SUB TITLE: FLOOR PLAN-VENTILATION

TITLE: MECHANICAL MASTER

COL. E-H, 32-40 BLDG. 12.02

SHEET M-42 OF

PARTIAL FIRST FLOOR PLAN

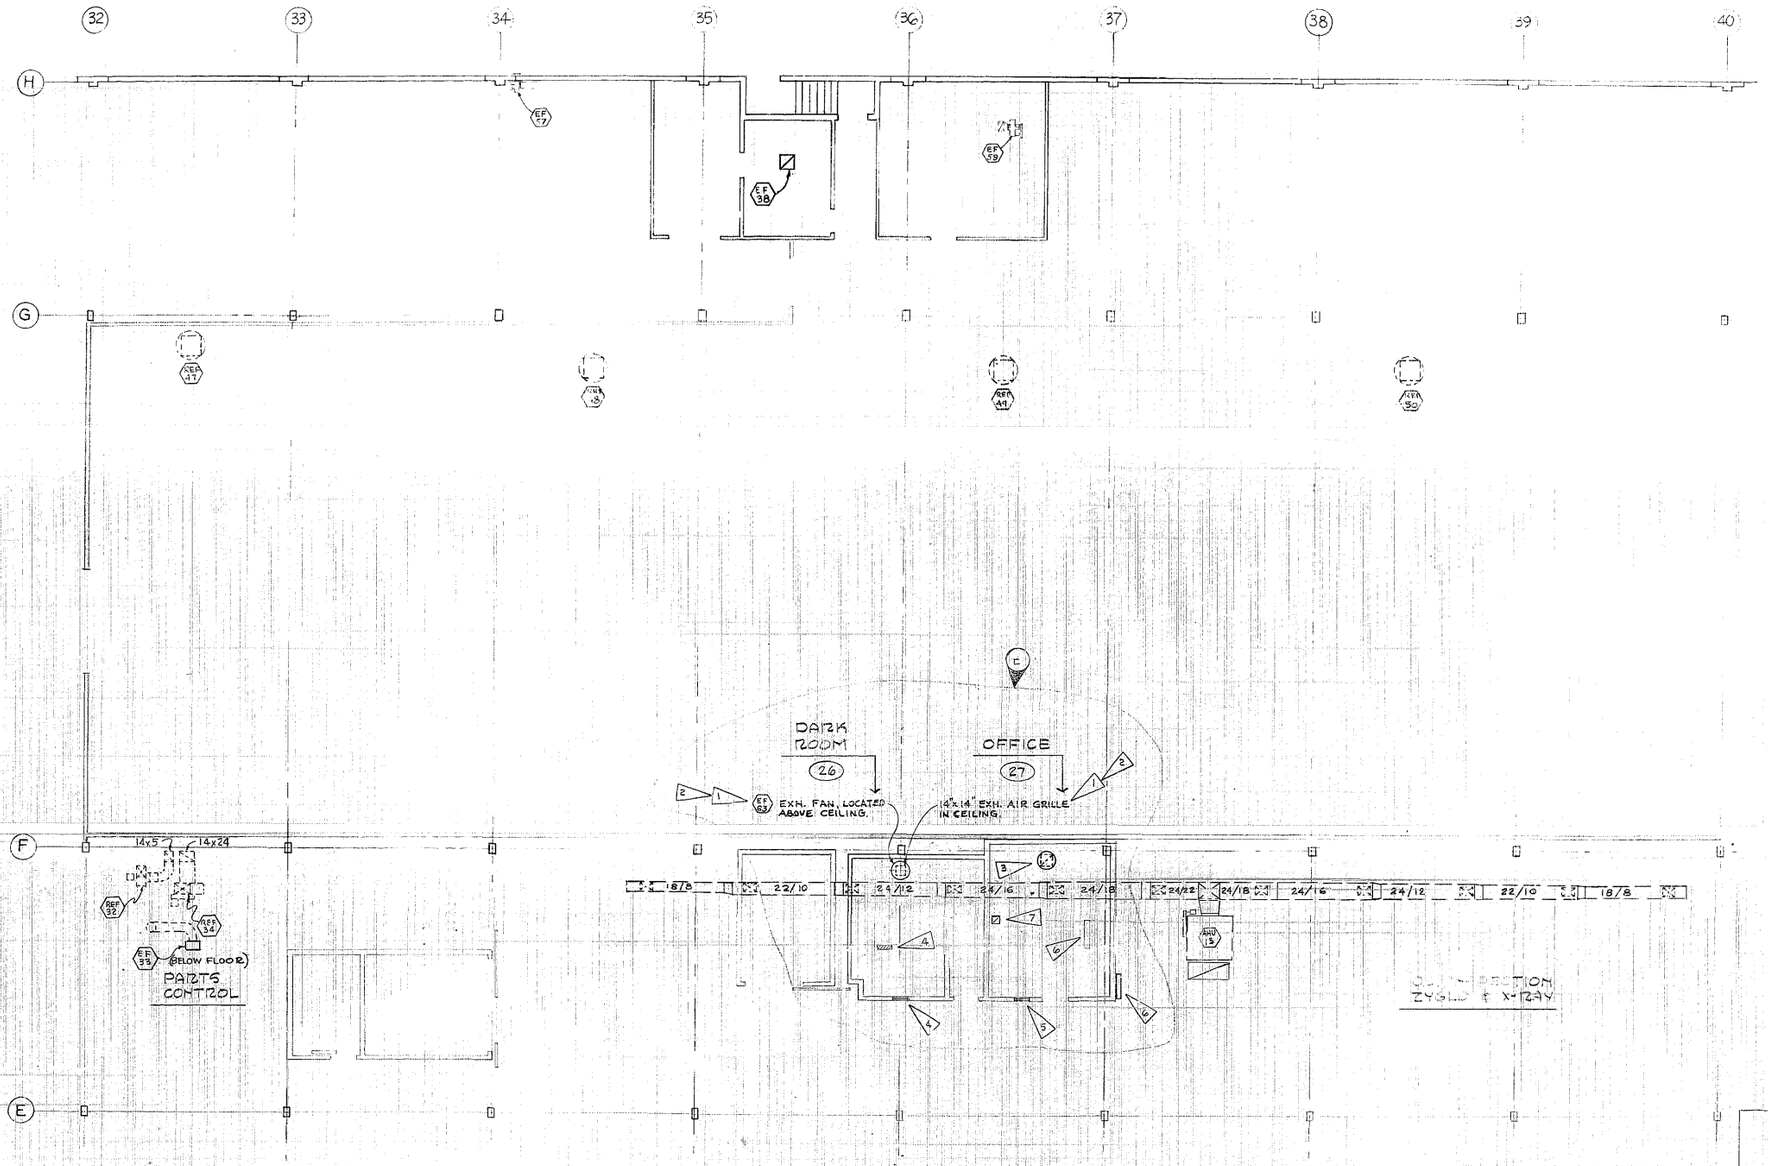
1. REMOVE EXISTING DARK ROOM ROOF EXHAUST FAN & 14"X14" EXHAUST AIR GRILLE.
2. REINSTALL 14"X14" EXHAUST AIR GRILLE IN NEW [illegible] CEILING. PROVIDE & INSTALL NEW JENN AIR MODEL [illegible] ROOF EXHAUST FAN, 345 CFM @ 1/4" SP, 860 RPM, 1/2 HP 120 V., 1 PH. COMPLETE WITH BACKDRAFT DAMPER.
3. PROVIDE & INSTALL NEW JENN AIR MODEL 108 CR ROOF EXHAUST FAN, 345 CFM @ 1/4" SP, 860 RPM, 1/2 HP, 120V 1PH, COMPLETE WITH BACKDRAFT DAMPER, 14"X14" EXHAUST AIR GRILLE, T&B T980WL, LIGHTPROOF, DEAD BLACK FINISH.
4. REMOVE EXIST. 20"X16" AIR RELIEF GRILLE IN EXIST DARK ROOM WALL & RE-INSTALL IN NEW DARK ROOM WALL
5. PROVIDE NEW 20"X16" AIR RELIEF GRILLE WITH 1" THICK THROWAWAY TYPE FIBERGLASS FILTER & FRAME. INSTALL NEAR CEILING. GRILLE TO BE T&B T980WL, LIGHTPROOF, DEAD BLACK FINISH.
6. RELOCATE EXIST. AHU 13 CONTROL PANEL.
7. 10"X10" DUCT THRU CEILING FROM FILM DRYER

SYM.	REVISION	BY	APPROVED	DATE
E	REVISED DARK ROOM, ADDED INTERPRETATION ROOM	RWP	K.KINZER FOR J.A.	8-7-68
D	AS BUILT	EISI	RWP	3/15/68
C	ISSUED FOR PHASE II	EISI	GHT	9/25/67
B	ISSUED FOR CONSTRUCTION	EISI	GHT	9/1/67
A	ISSUED FOR BID-CONTRACT ASD (FAC) 67-28	EISI	GHT	6/12/67
